April 2019
SF572AB

Subject: Radiator Pipe and Steering Hose Interference

Models Affected: Specific Freightliner 114SD and Western Star 4700 model vehicles manufactured December 11, 2017, through April 9, 2018

Fig. 1, Power Steering Reservoir Set Aside

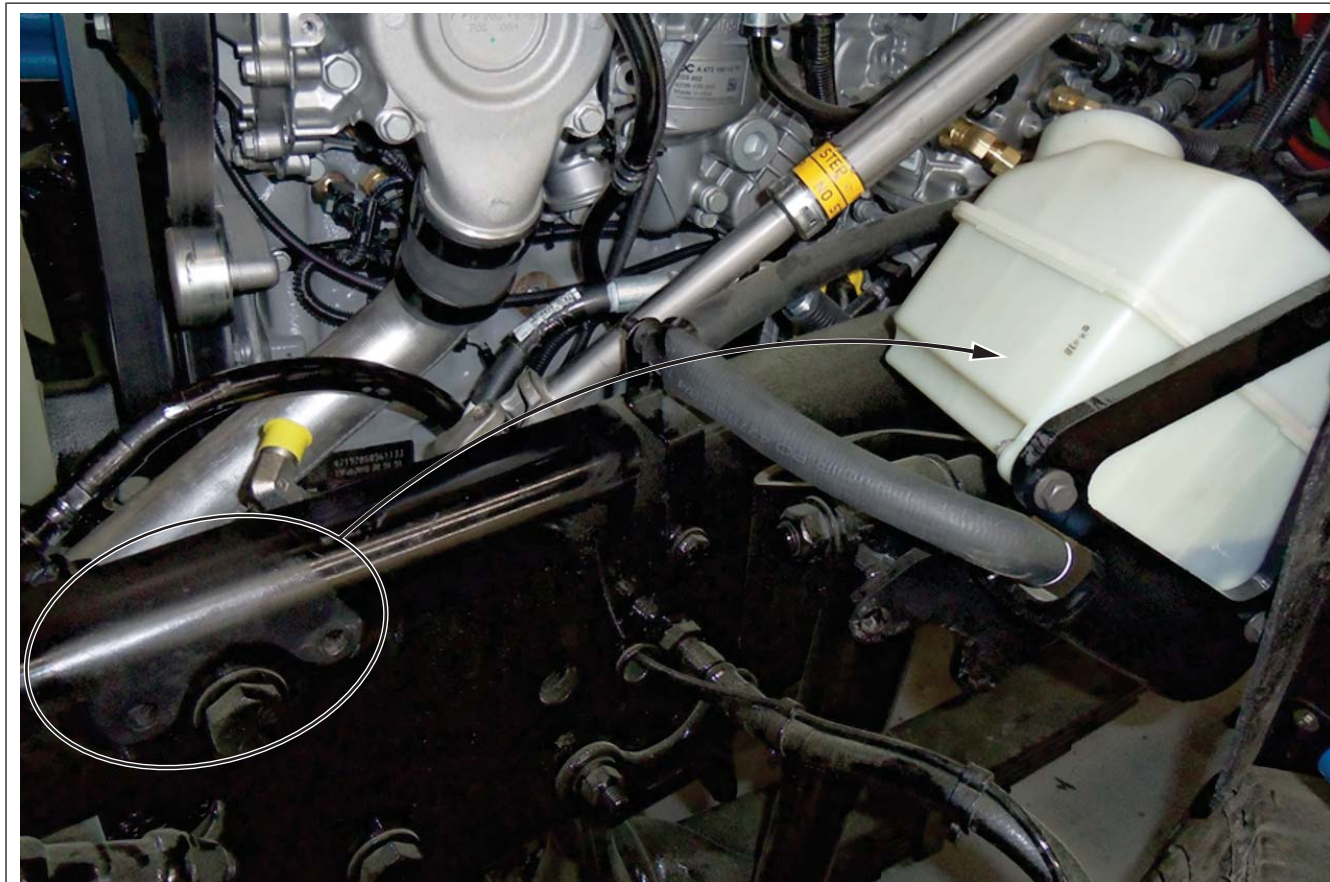
1. Park the vehicle on a level surface, shut down the engine, and set the parking brake. Chock the tires. Open the hood.
2. Pinch off the lower power steering reservoir hose.
3. Leaving the hoses connected, remove the bolts holding the power steering reservoir to the rail and set the reservoir aside. See [Fig. 1](#).

Fig. 3, Fastener Locations

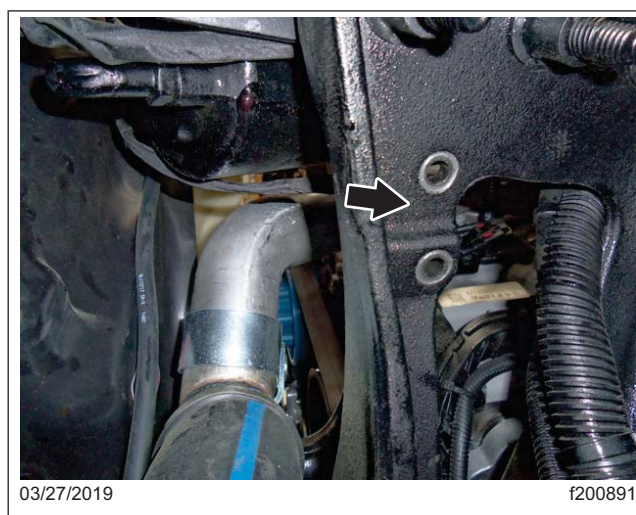
7. Accessing them from underneath the engine cross member, remove the two bolts that are holding the remainder of the old hard lines to the cross member and remove the hard lines. See [Fig. 3](#). Save the bolts and fasteners.

Fig. 4, Tab to Remove

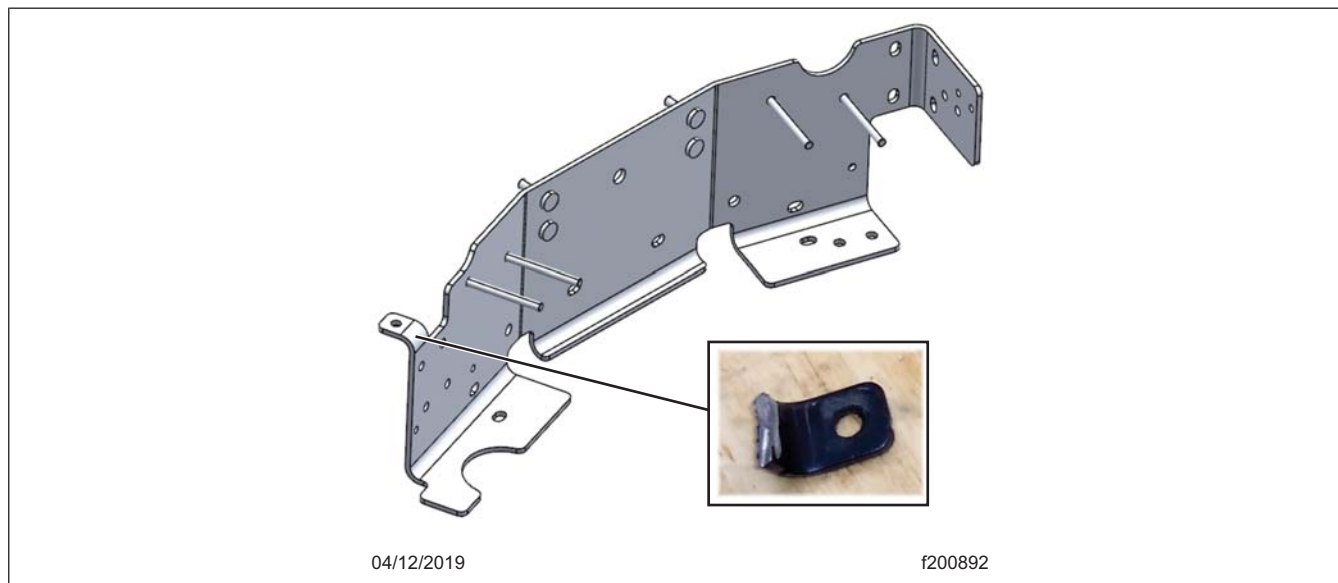
8. Cut the tab off the brake valve bracket. See [Fig. 4](#).

9. Paint the exposed cut surface of the bracket.
10. Remove the fitting in the top of the steering gear and install new 90 degree fitting (part no: 23-11000-801). Torque the jam nut on the pressure line fitting to 37 lb·ft (50 N·m). See [Fig. 5](#).

Fig. 5, New Layout Overview

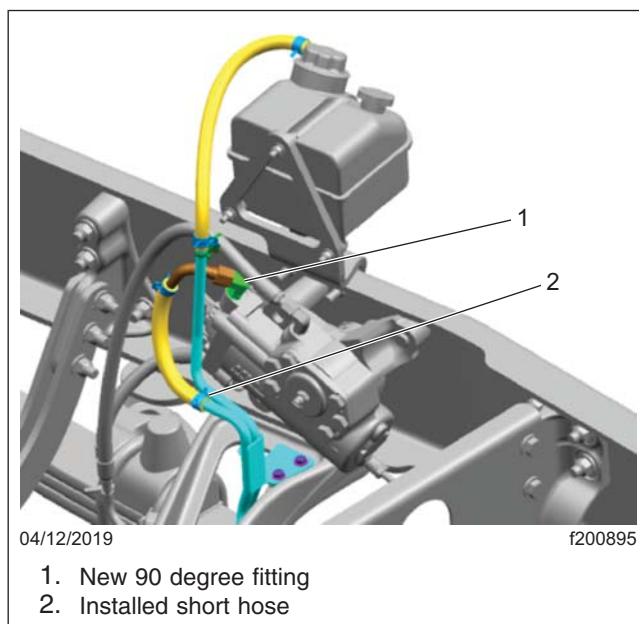
11. Install a new short hose on the 90 degree pipe. See [Fig. 5](#).
12. Accessing the area from underneath the vehicle, install the new hard line assembly using the mounting fasteners. Torque to 26 lb·ft (35 N·m).

9. Install the new brake bracket. Torque the bolts to 26 lb·ft (35 N·m).
10. Remove the fitting in the top of the steering gear and install new 90 degree fitting (part no: 23-11000-801). Torque the jam nut on the pressure line fitting to 37 lb·ft (50 N·m). See [Fig. 5](#).

11. Install a new short hose on the 90 degree pipe. See [Fig. 5](#).
12. Accessing the area from underneath the vehicle, install the new hard line assembly using the mounting fasteners. Torque to 26 lb·ft (35 N·m).

Fig. 6, Secure the brake lines to the New Hard Lines

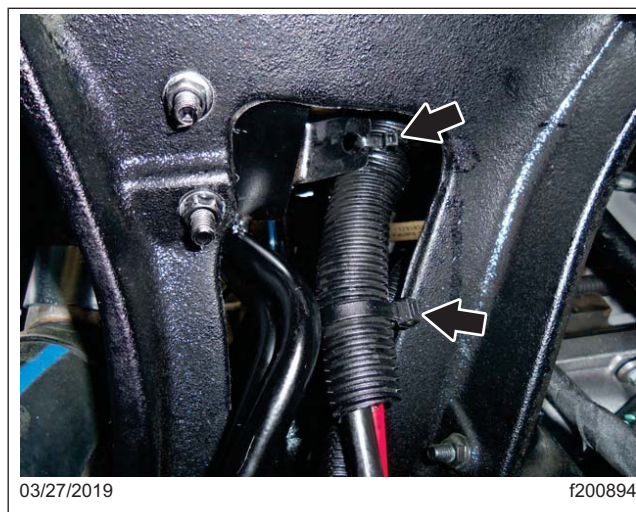
13. Connect the two power steering hoses running from the cooler to the new hard line assembly. Attach the short hose to the top of the hard line.
14. Using a tie strap, secure the brake lines to the new hard lines to avoid rubbing. See [Fig. 6](#).

13. Connect the two power steering hoses running from the cooler to the new hard line assembly. Attach the short hose to the top of the hard line.
14. Using a tie strap, secure the brake lines to the new hard lines to avoid rubbing. See [Fig. 6](#).
